BFD-68 Boot Delay after Power On

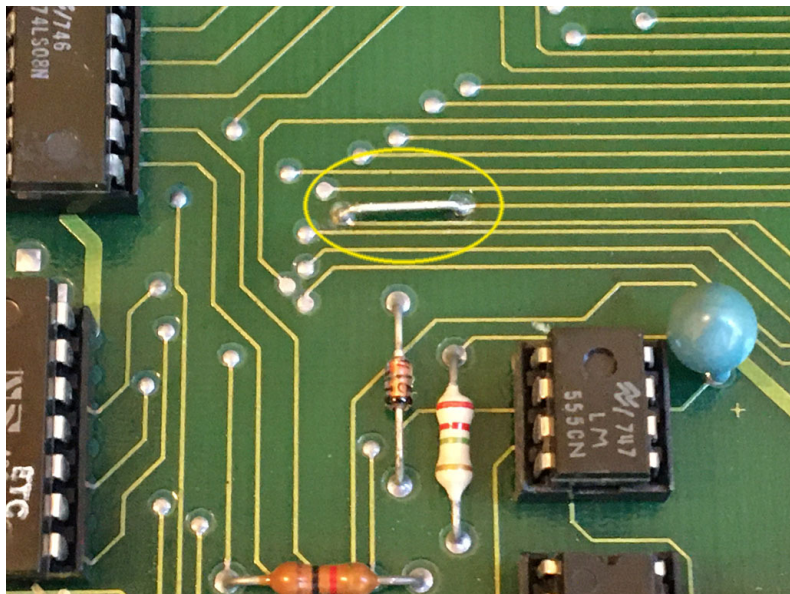
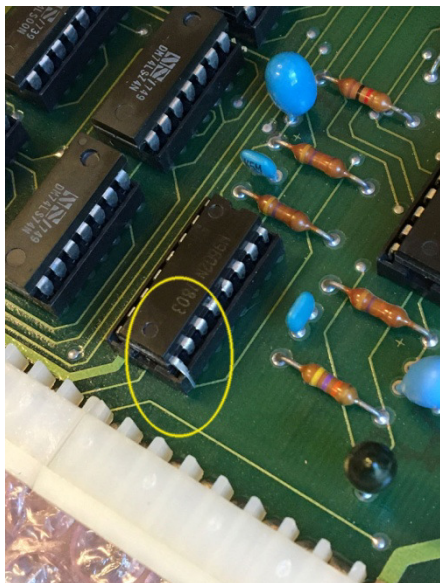
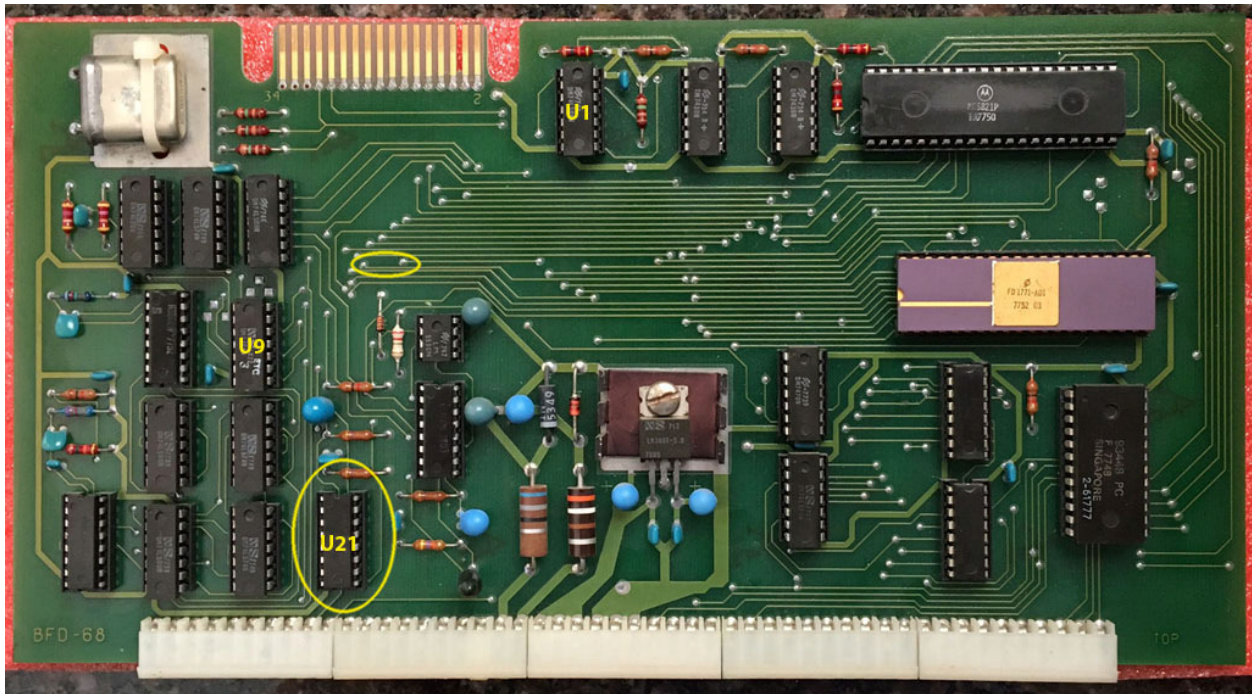
The ten second delay can be eliminated with a minor board mod that makes the BFD-68 work the same as the "A" version of the controller in regard to this problem. See the two areas circled in yellow below.

- 1) Lift pin 9 of U21 out of its socket
- 2) Install a jumper between the pads circled in yellow closer to the top of the board

This mod connects the head load output (HLD) of the 1771 (pin 28) to U1 pin 1, replacing the FKTR00 signal previously connected to U1 pin 1. FKTR00 comes from U21 pin 9 which is disconnected by lifting the pin out of its socket. The HLD signal is picked up at a feedthru going to U9 pin 1.
